Access Compliance Report

(Curb Ramps)

Intersection ID: 47929	Main Street: MOORES_CHAPEL_RD	Cross Street: KENDALL_DR	Location:	N/A
ADA ID: C021798086B2	Ramp Type: Perp	Initial Pass/Fail: Fail	Overall Compliance: No	Severity Score: 1.25
Codes/Mitigation Info/Possible Solution		Field Measurements/Component Compliance

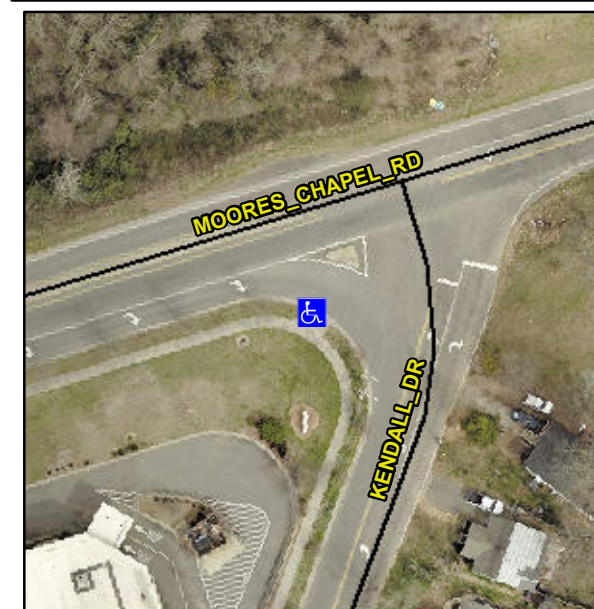
Not Found, R304.5.3

Compliance	Description	Data	Compliance	Description	Data
N/A	Ramp Length (in)	97.5	Yes	Ramp Slope (%)	6.3
Yes	Ramp Width (in)	55.0	No	Ramp XSlope (%)	2.3
N/A	Flare Type LT	N/A	N/A	Flare Type RT	N/A
N/A	Flare Slope LT (%)	N/A	N/A	Flare Slope RT (%)	N/A
N/A	Flare Traversable LT?	N/A	N/A	Flare Traversable RT?	N/A
N/A	Landing Length (in)	N/A	N/A	DWS Provided?	N/A
N/A	Landing Width (in)	N/A	N/A	DWS Contrast?	N/A
N/A	Landing Slope (%)	N/A	N/A	DWS Length (in)	N/A
N/A	Landing X Slope (%)	N/A	N/A	DWS Full Width?	N/A
N/A	Landing Curb? (Y/N)	N/A	N/A	DWS Offset (in)	N/A
N/A	Shared Landing?	N/A			
N/A	Gutter Ponding?	N/A	N/A	Gutter Slope (%)	N/A
N/A	Gutter Lip Ht (in)	N/A	N/A	Gutter X Slope (%)	N/A
N/A	Painted X Walk1?	No	N/A	Painted X Walk2?	N/A
	X Walk 1 Direction	To E		X Walk 2 Direction	N/A
N/A	X Walk 1 Width (in)	N/A	N/A	X Walk 2 Width (in)	N/A
	X Walk 1 Slope (%)	5.5		X Walk 2 Slope (%)	N/A
	X Walk 1 X Slope (%)	2.4		X Walk 2 X Slope (%)	N/A

Remove & Replace Entire Ramp.
